Subject: Comments on the Tentative NPDES Permit for the AES LLC Alamitos
Generating Station

Enclosure 1

Tentative Waste Discharge Requirements (WDRs) and
National Pollutant Discharge Elimination System (NPDES
Permit / Tentative Time Schedule Order – AES Alamitos
Generating Station, 690 N. Studebaker Road,
Long Beach, California
(NPDES Permit No. CA0001139, CI-6113)

Exhibit 1

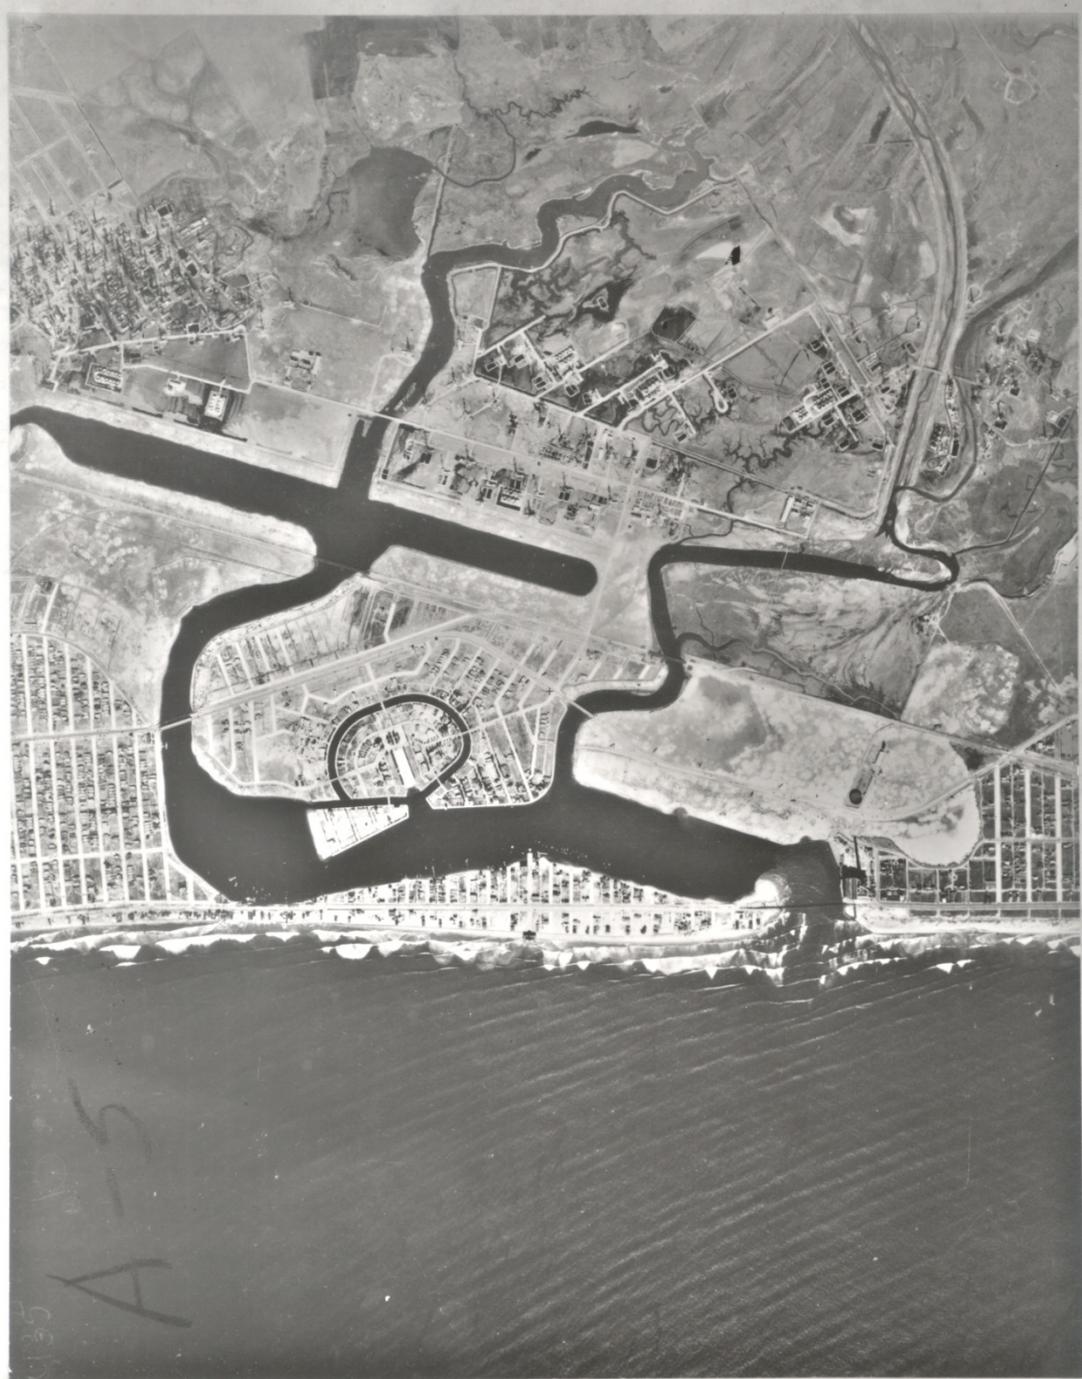
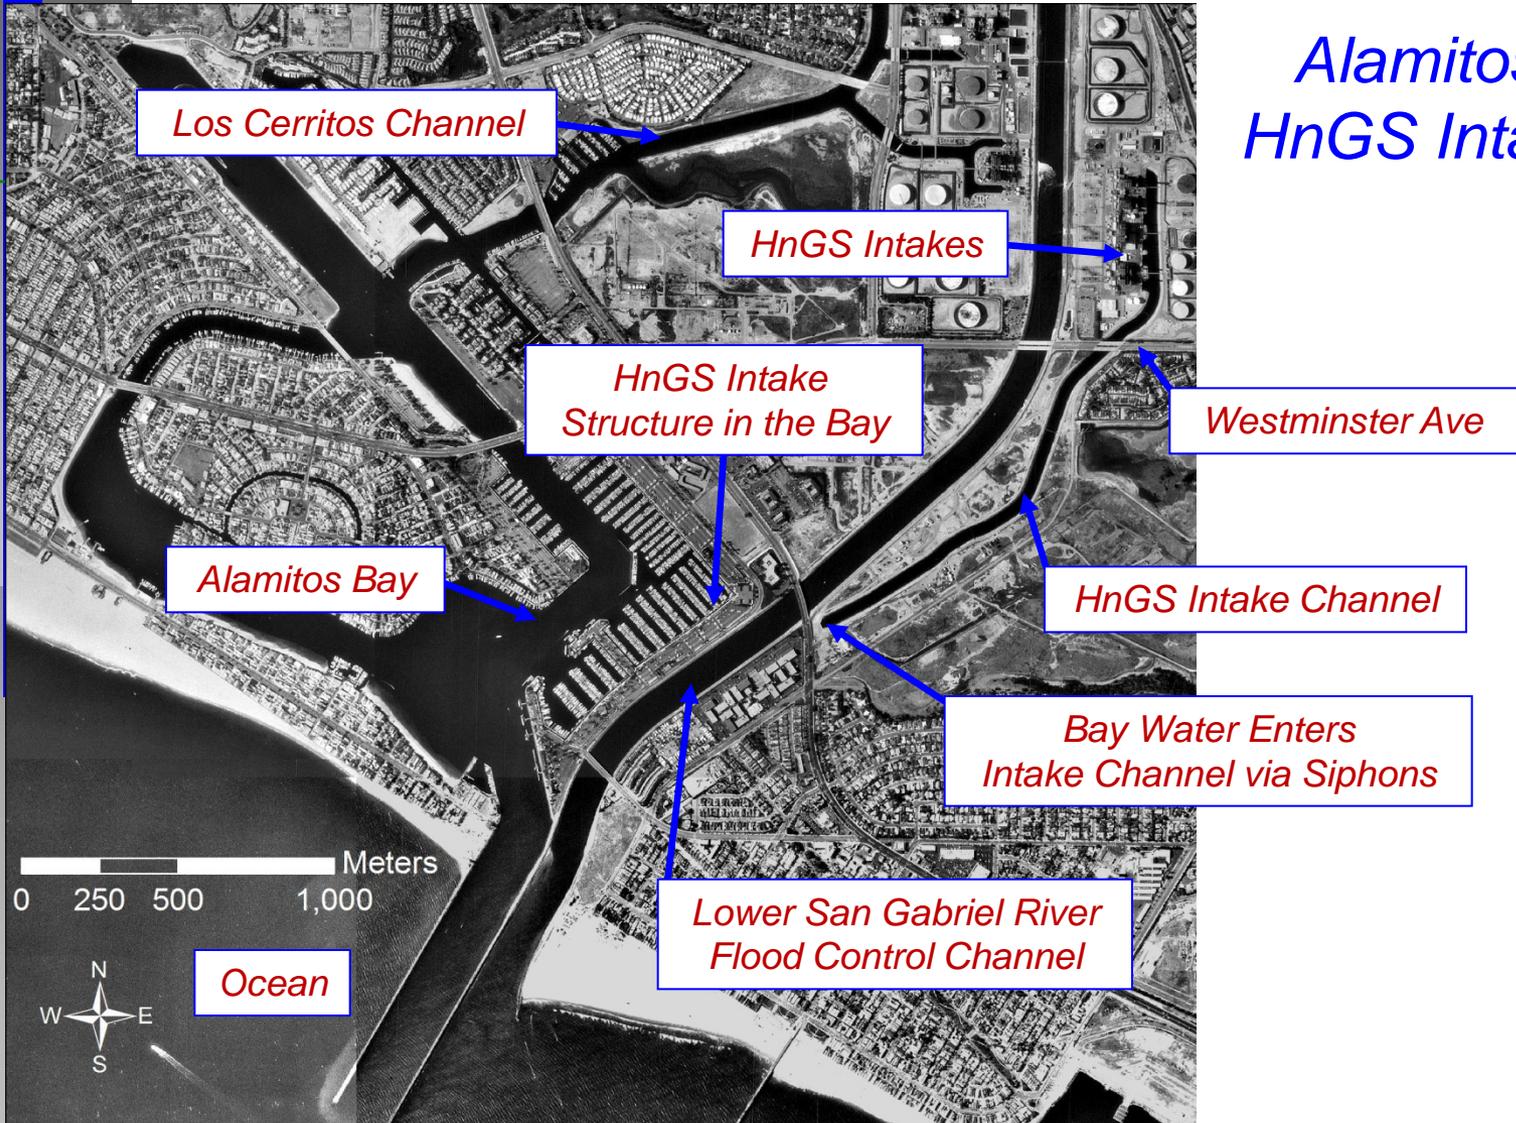
The San Gabriel River originally discharged to the San Pedro Bay. In 1938, major flooding occurred, and the San Gabriel River was diverted to the southern end of the Alamitos Bay. In 1951, the San Gabriel River silted up and jetties were constructed at the entrance to Alamitos Bay. In 1959, the jetties were completed and the operations of the power plants cleared the silt from the flood control channel. In 1962, the Marina was completed, and the Los Cerritos Channel discharged to the Marine Stadium. The outlet of the San Gabriel River in its present location is a result of two previous diversions designed primarily to keep floods and sediment out of the Alamitos Bay and the Marina.

Between the mouth of the River and the power plant discharge points, the channel contains saline water that originated from the San Pedro Bay and entered the plants via the Alamitos Bay, the source of the cooling water used by the plants. When the lower San Gabriel River was modified to create a fixed flood control channel, the function and purpose of the river were permanently altered. A new ecological baseline was established by the construction of the flood control channel and the introduction of the power plant discharges in 1956 (See photos Exhibit 1).
